Architects Supplemental Instructions

PROJECT: <i>(Name and address)</i> 22056 - Sussex County Courthouse Jurors Entrance Enclosure 1 The Circle Georgetown, DE 19947	CONTRACT INFORMATION: Contract for General Construction Date: July 22, 2025 DFM Proj. No. MC0201000028A	ASI INFORMATION: ASI No. 001 Date: 8/15/2025
OWNER: <i>(Name and address)</i> State of Delaware OMB/DFM Haslet Armory 122 Martin Luther King Jr. Blvd S. Dover, DE 19901	ARCHITECT: <i>(Name and address)</i> R G Architects, LLC 200 West Main Street Middletown, DE 19709	CONTRACTOR: <i>(Name and address)</i> Conventional Builders Inc. P.O. Box 47 847 School Street Houston, DE

1: REVISED SHEET E11-1

ELECTRICAL
 PARTIAL
 RENOVATION
 FLOOR PLAN
 E11-1

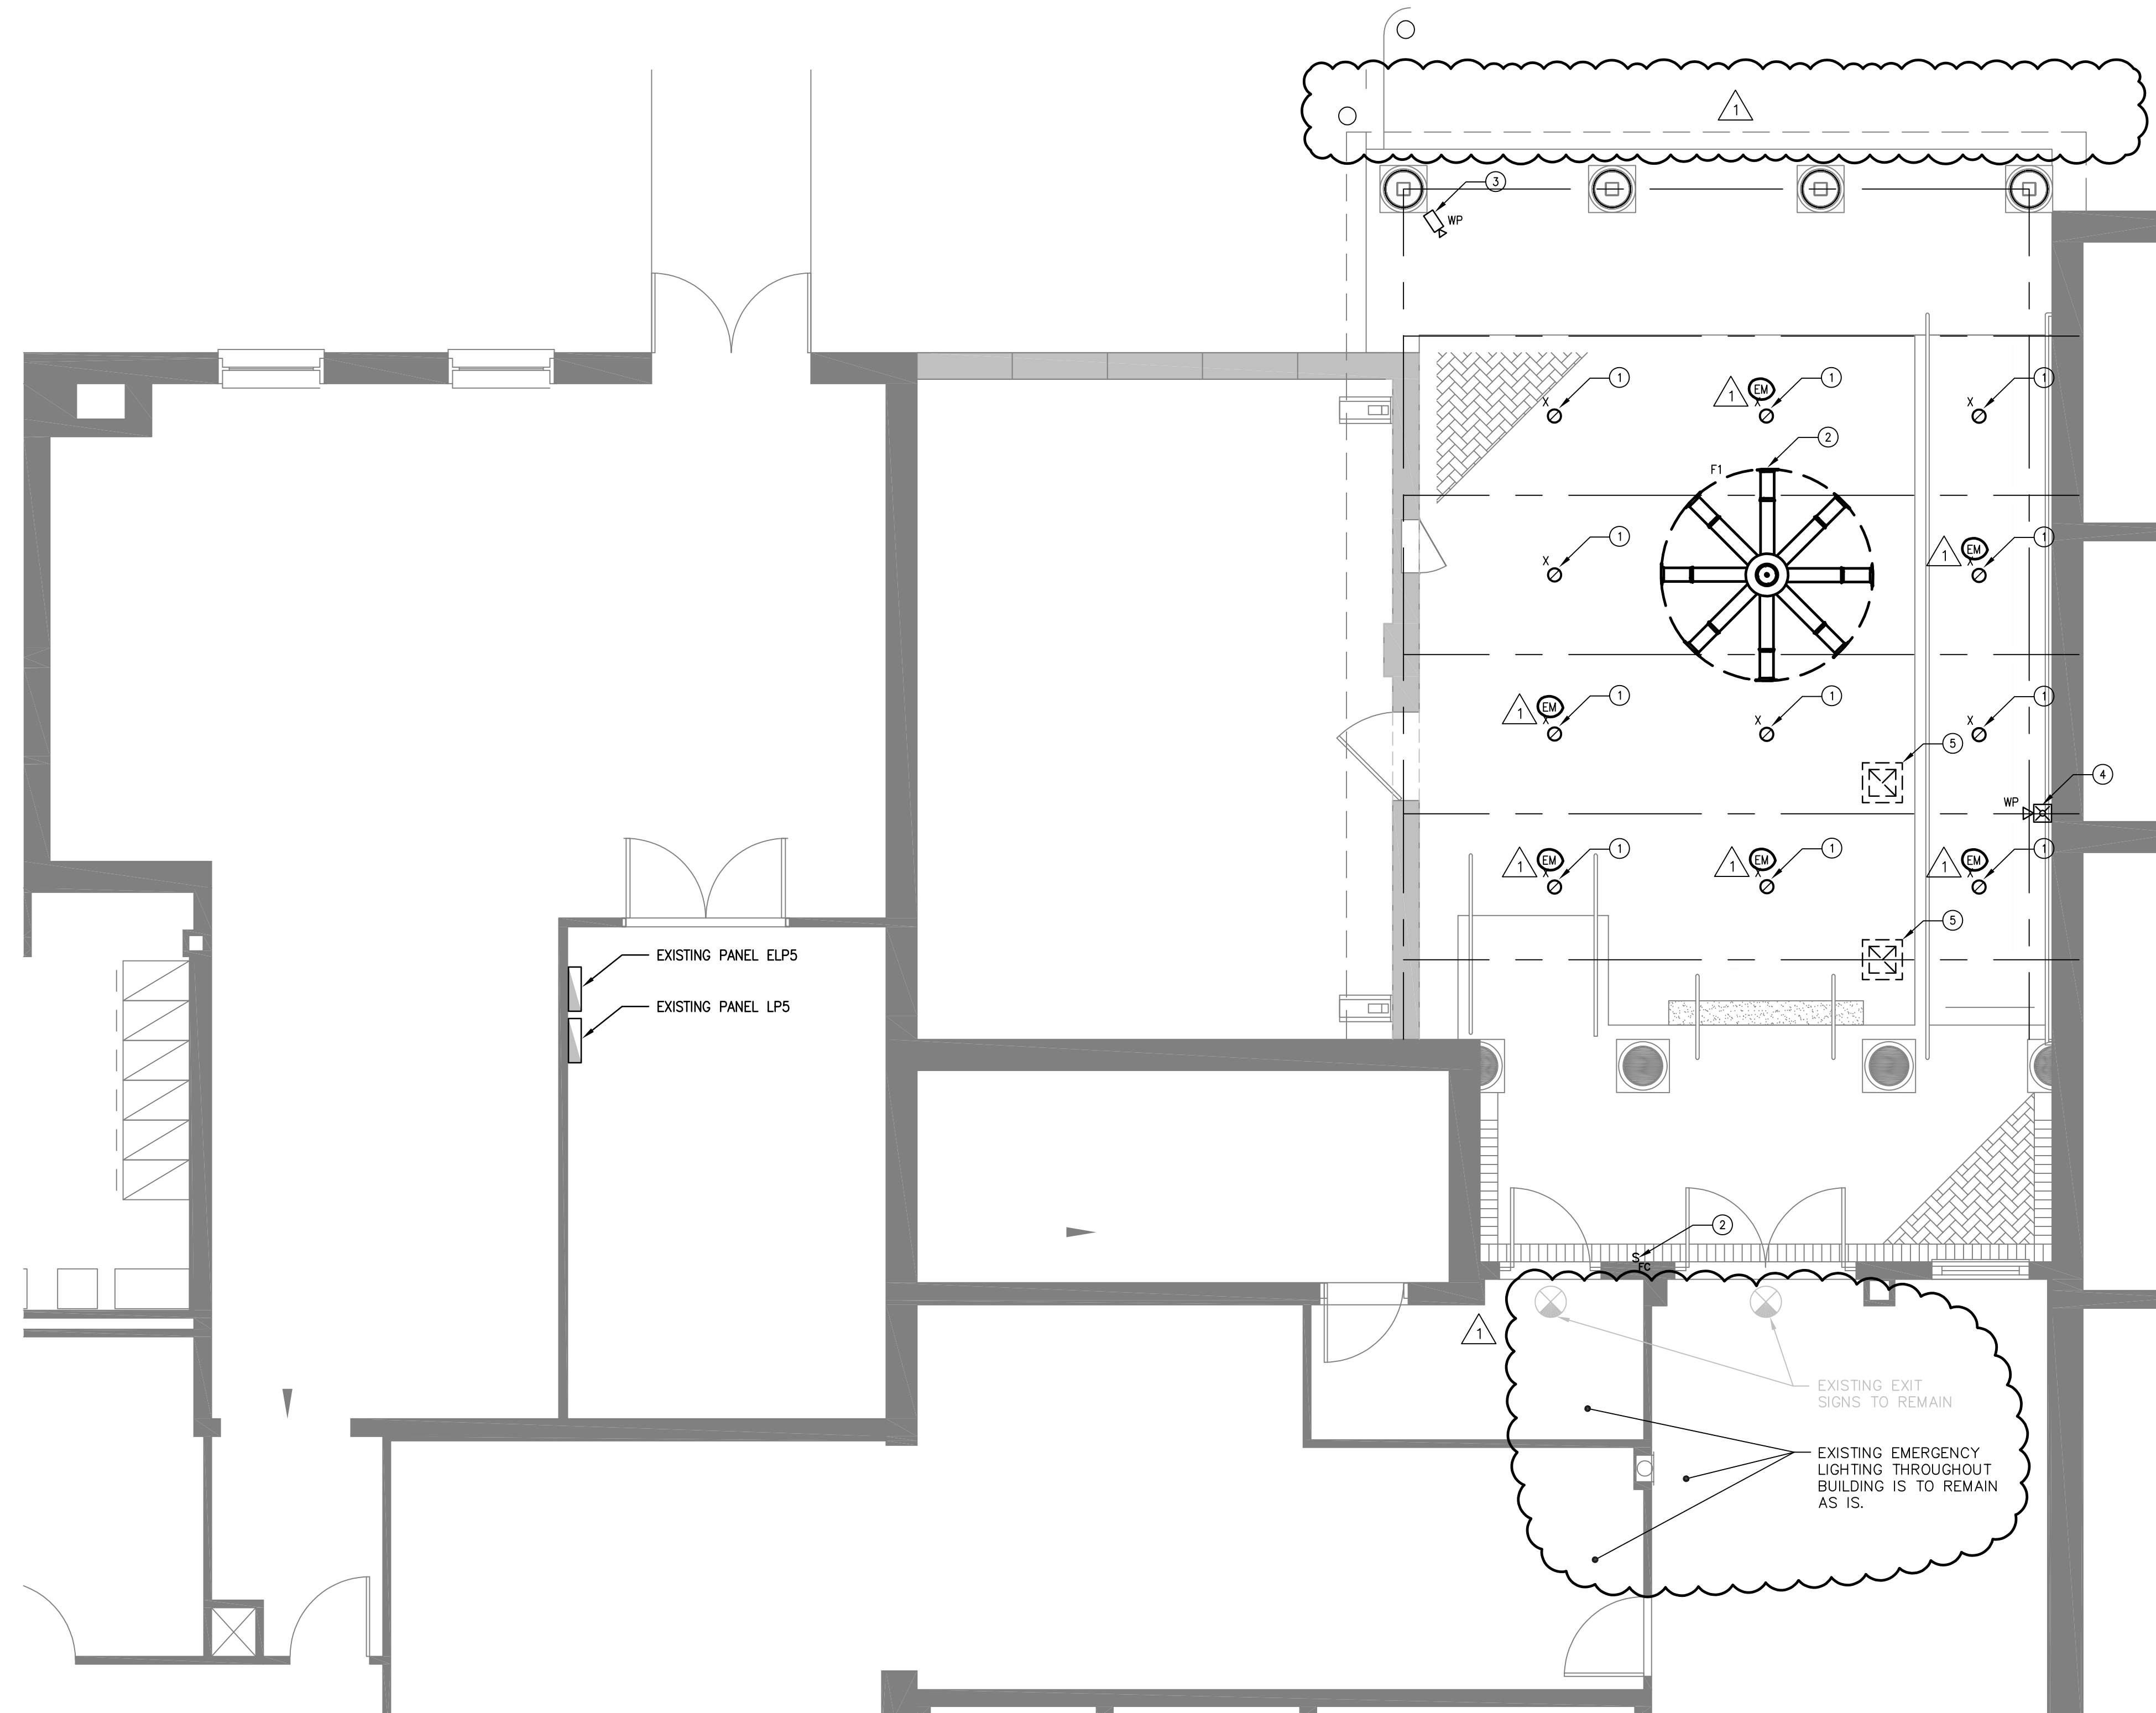
REVISED TYPE 'X' LIGHTING FIXTURE

In response to Fire Marshall comments:

OMITTED TYPE 'X1' LIGHTING FIXTURE

In response to RFI #2

Type 'X' lighting fixture is Noted in the Lighting Fixture Schedule with note 'EM' to lable fixture with Emergency Battery Backup.

Due to fixture requiring use of M/C cable and limited access in roof overhang, omit (4) four Type X1 fixtures shown in roof overhang.
